ADDENDUM NO: 01

BID PACKAGE NO: Kitchen Work Rebid

PROJECT: North and South Decatur Jr. / Sr. High School Additions and Renovations

PROJECT NO: DATE: 02/16/2024 BY: Emery H. M. Hunt

DRAWING NUMBER
T201

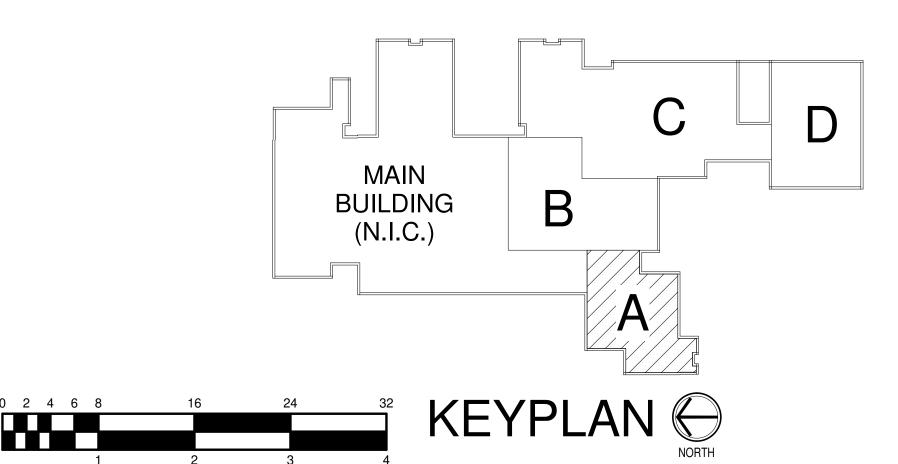
A. Remove all Electronic Access Control scope from the entrances between the Cafeteria and the Food Line.

DRAWING NUMBER A201

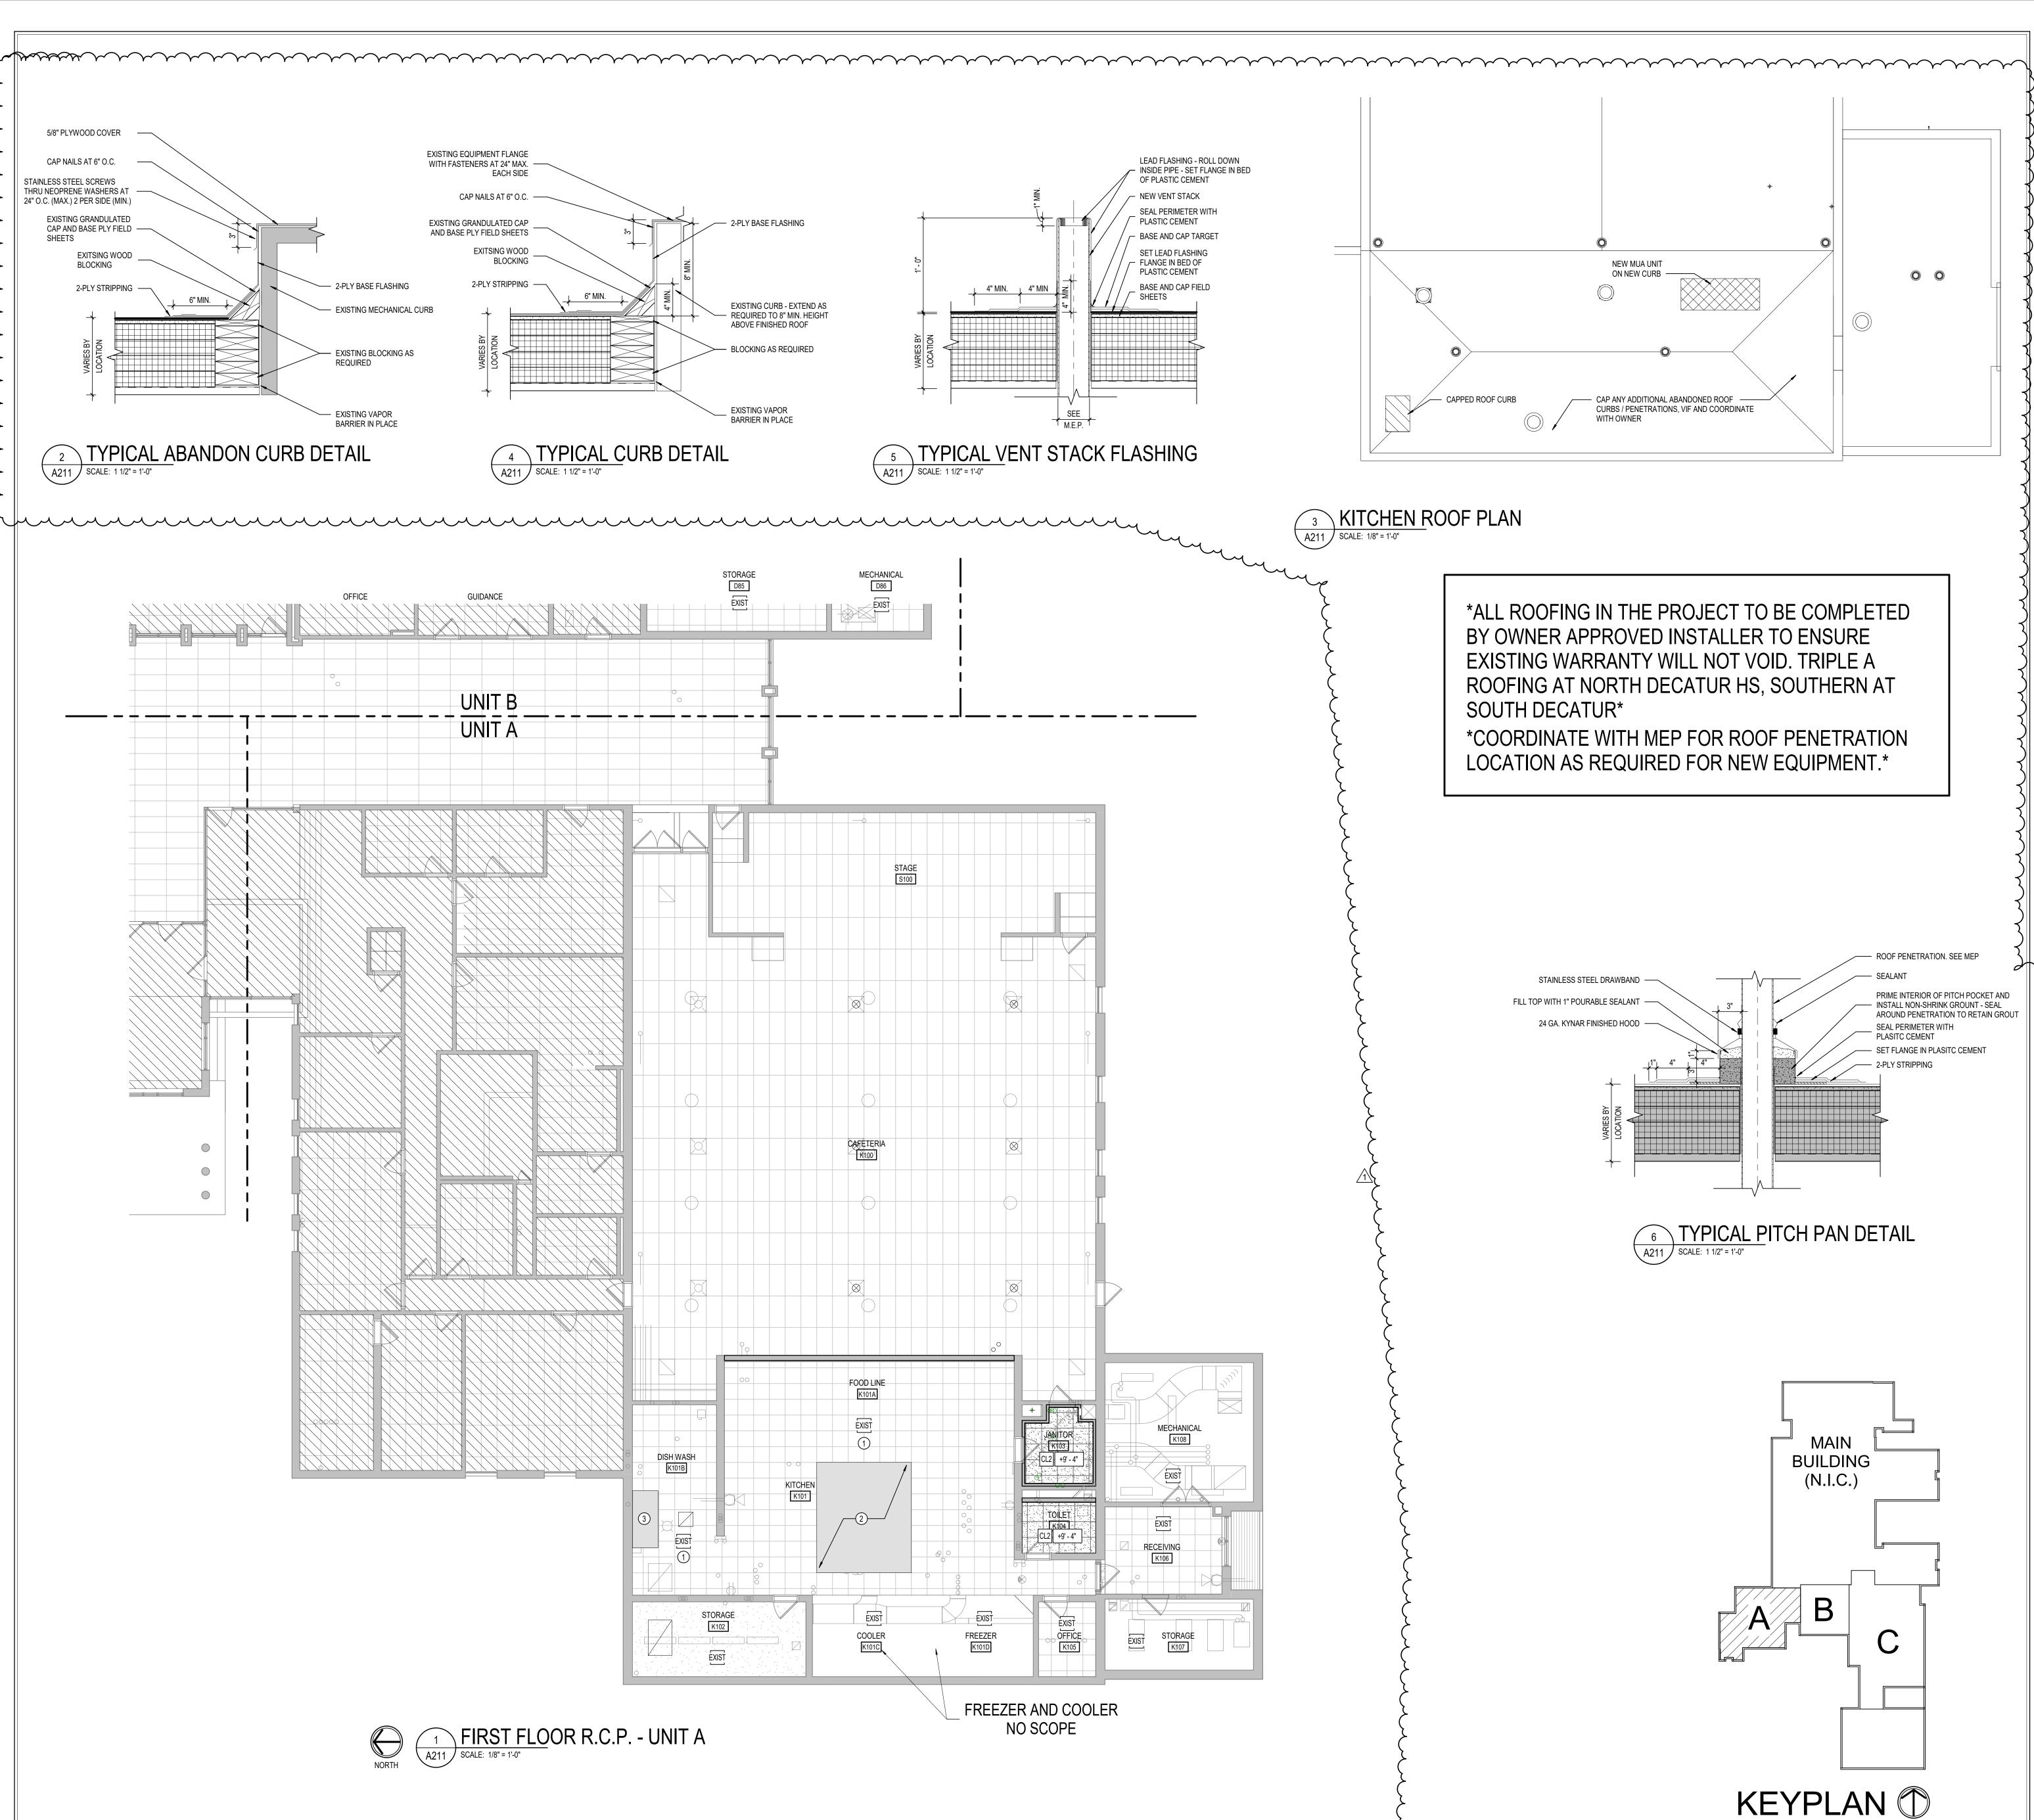
- A. Show alternate bid item for replacement of serving line replacement with new CMU wall and doors.
- B. Revise note 20
- C. Un-tag doors that where shown to receive access control.

DRAWING NUMBER
A211

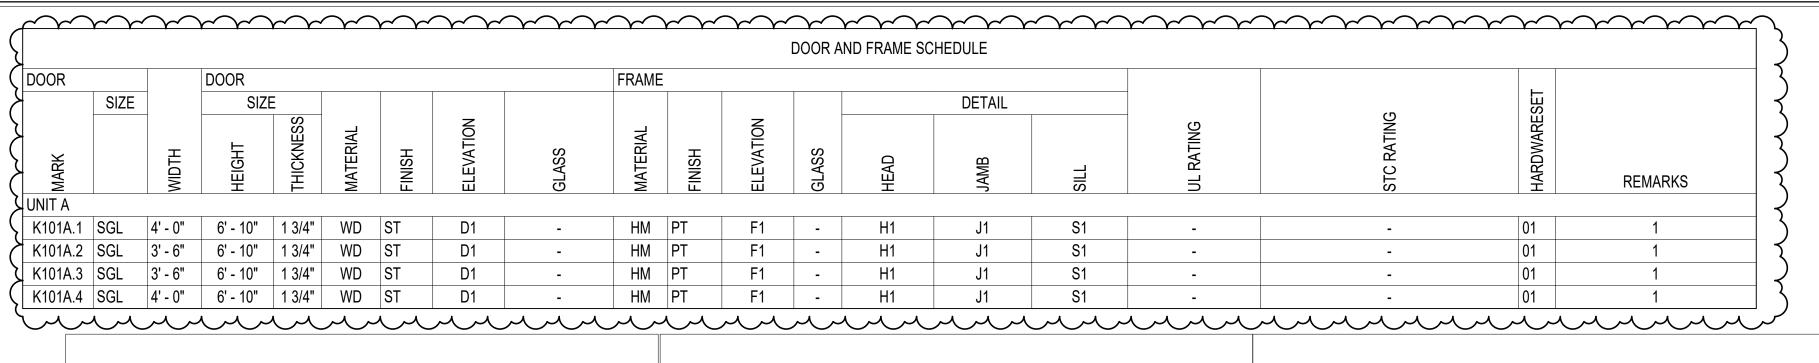
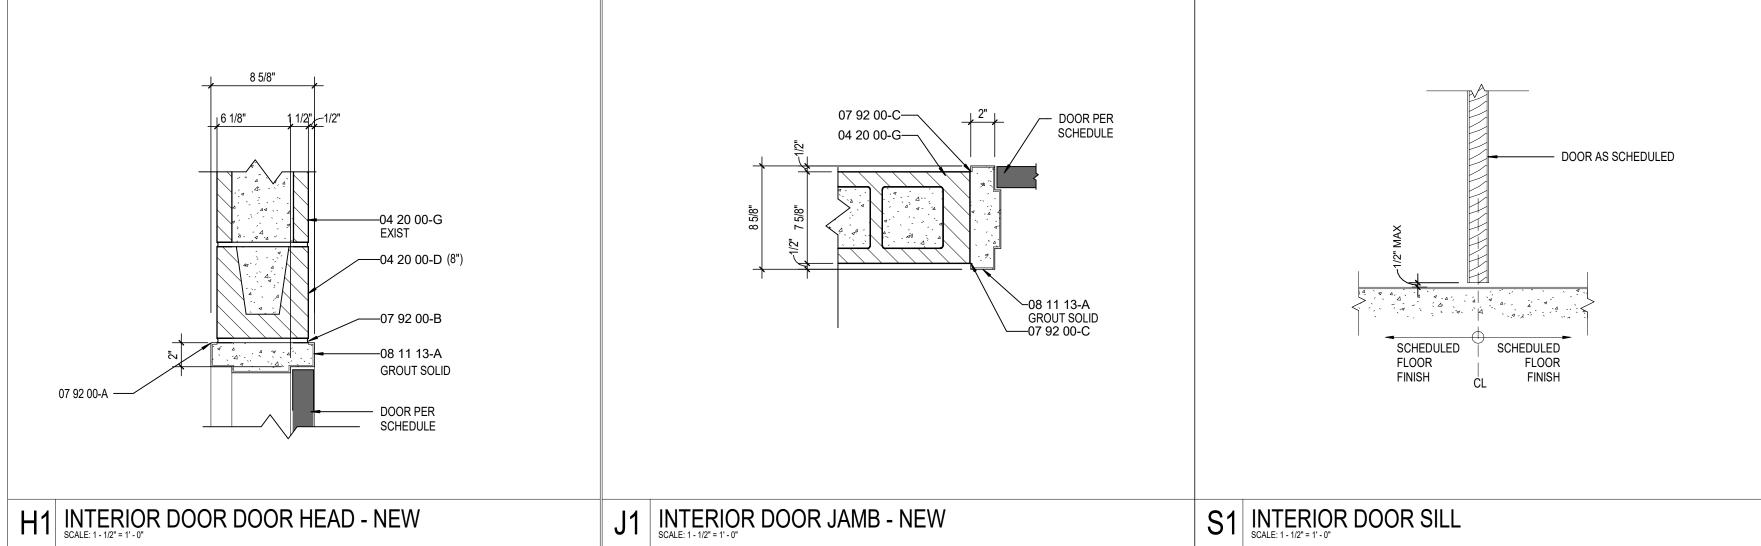
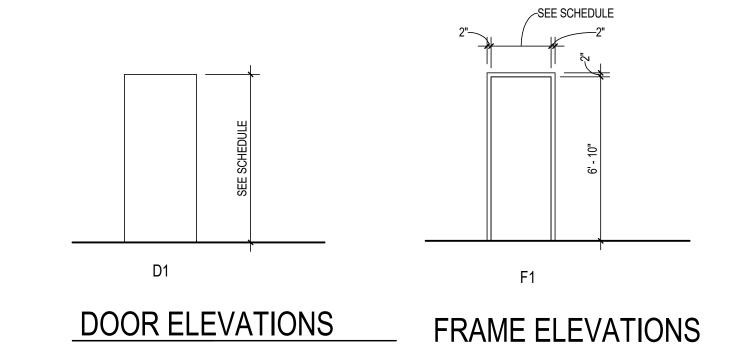
A. Add in roofing plan and typical details to sheet for kitchen roof.

A501

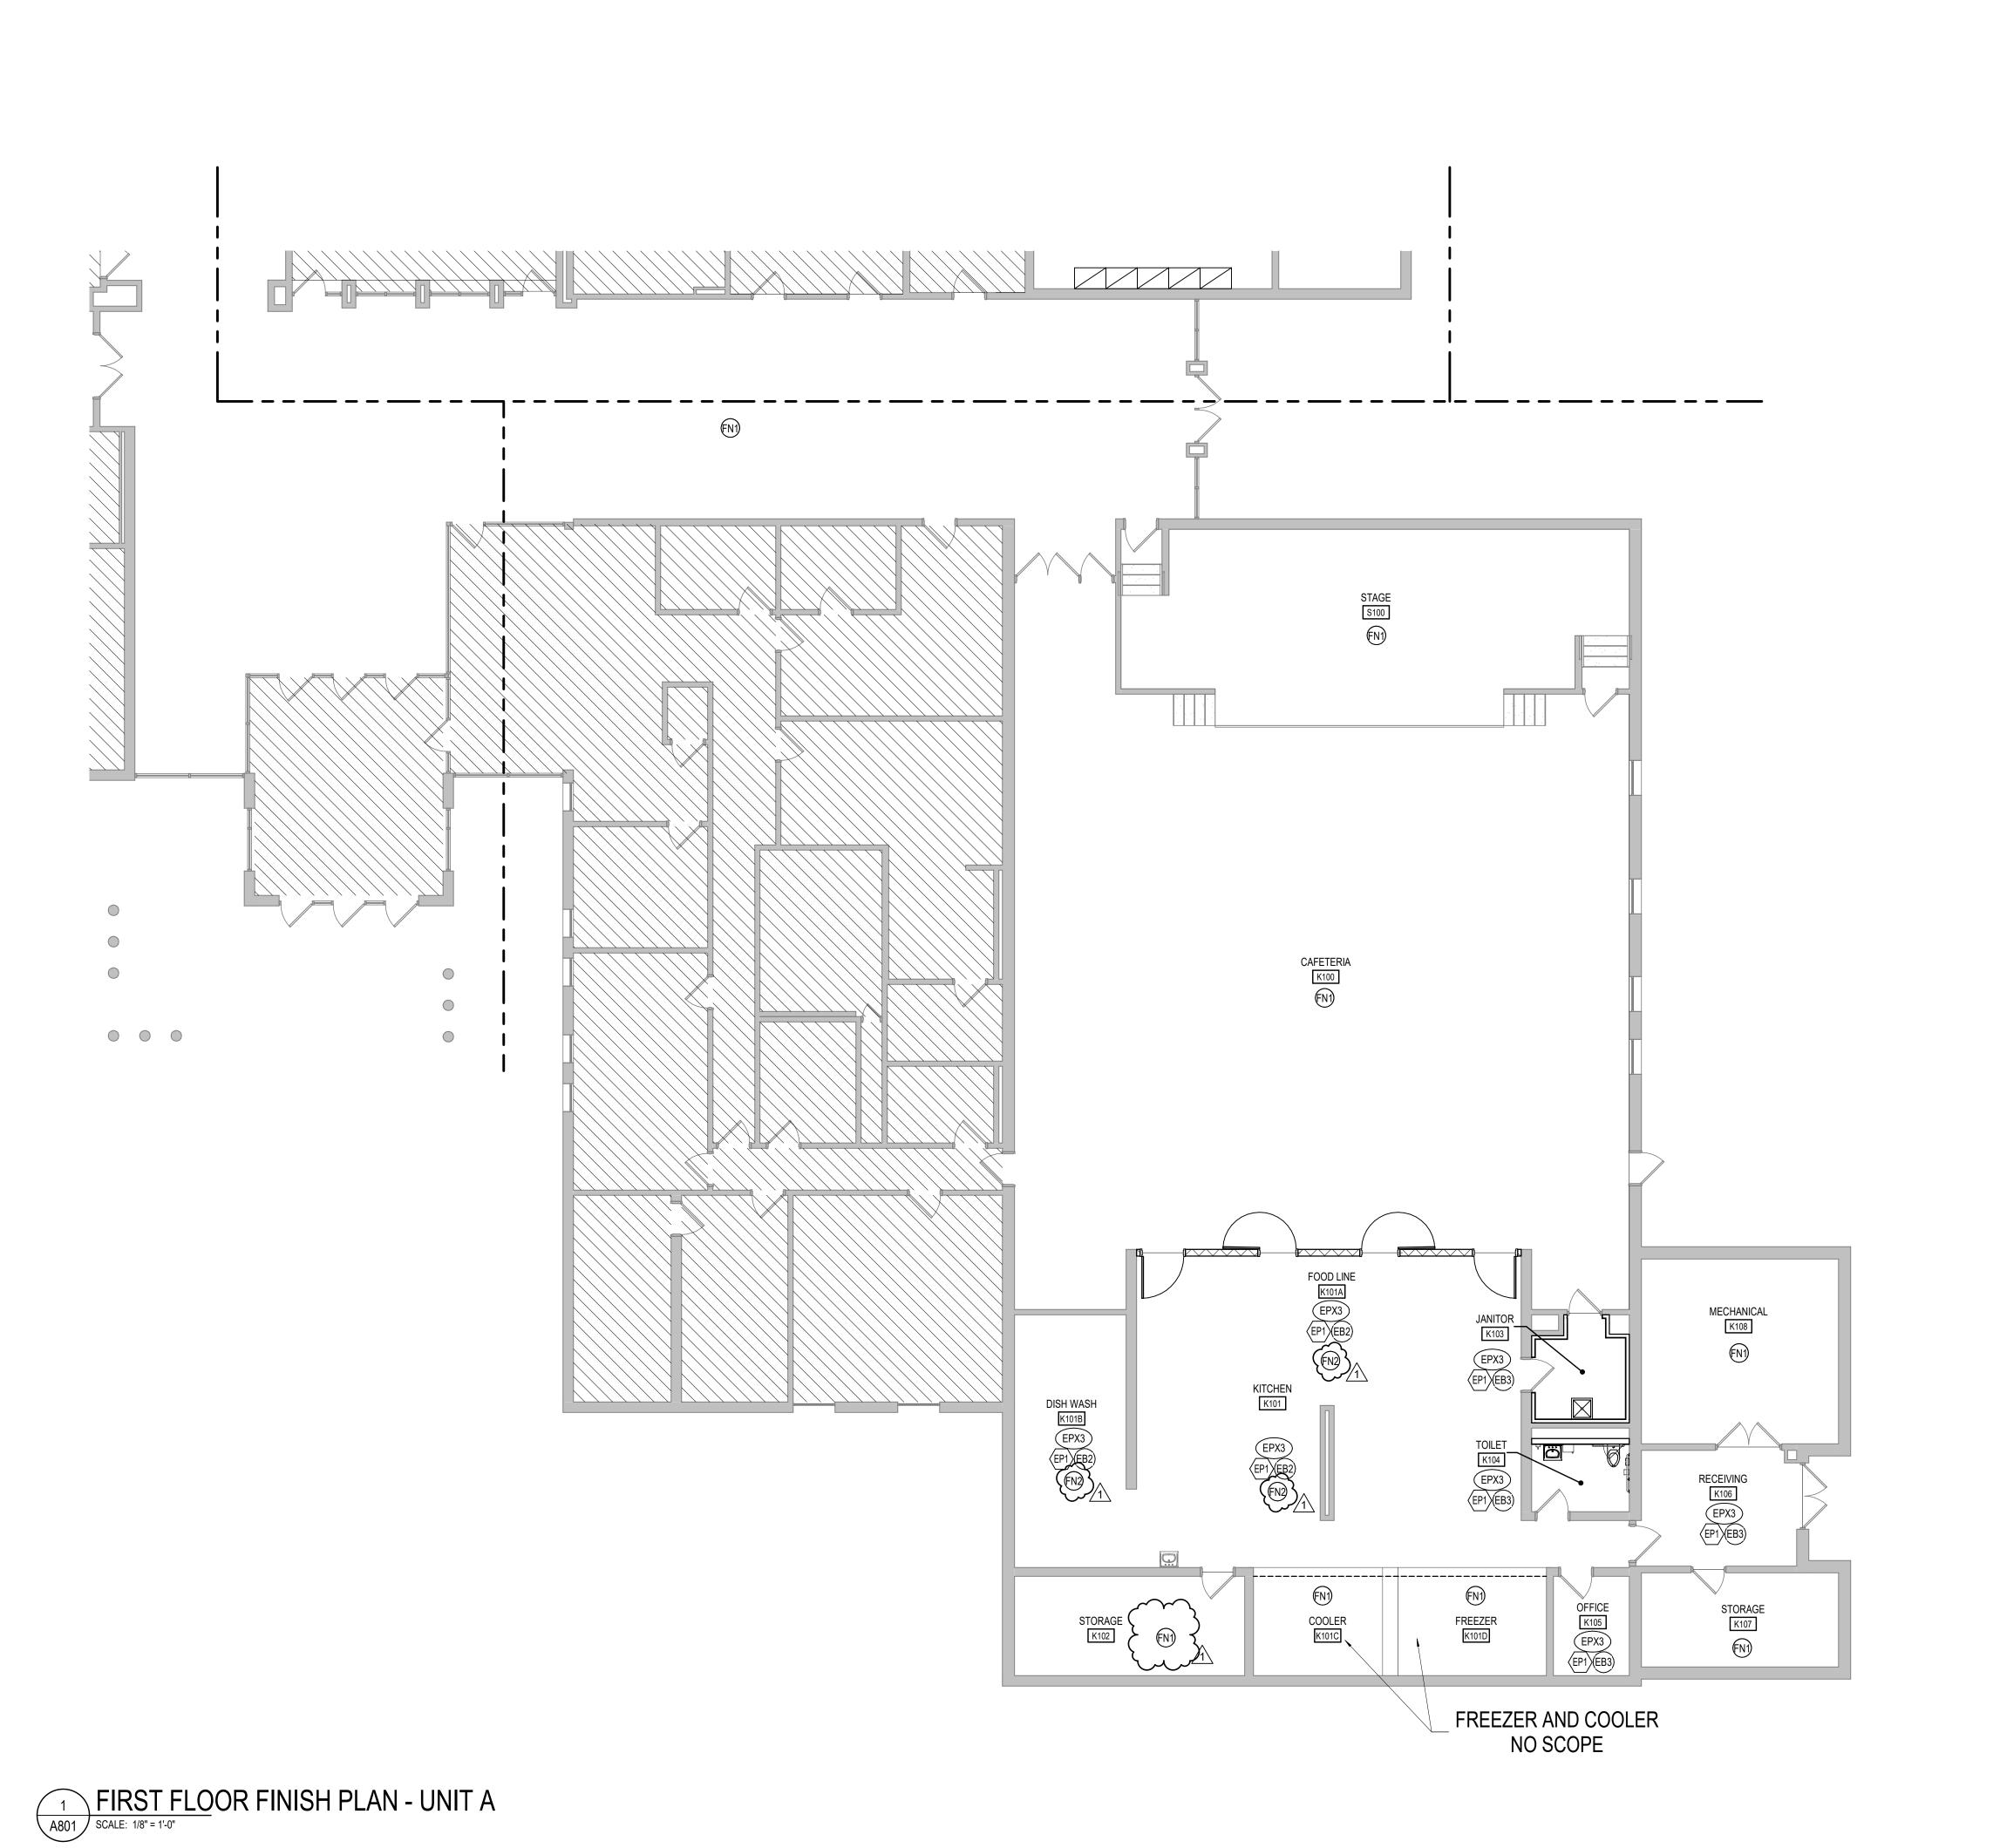
- A. Reissue sheet for new doors in alternate bid.
- B. Revise door remarks as shown.
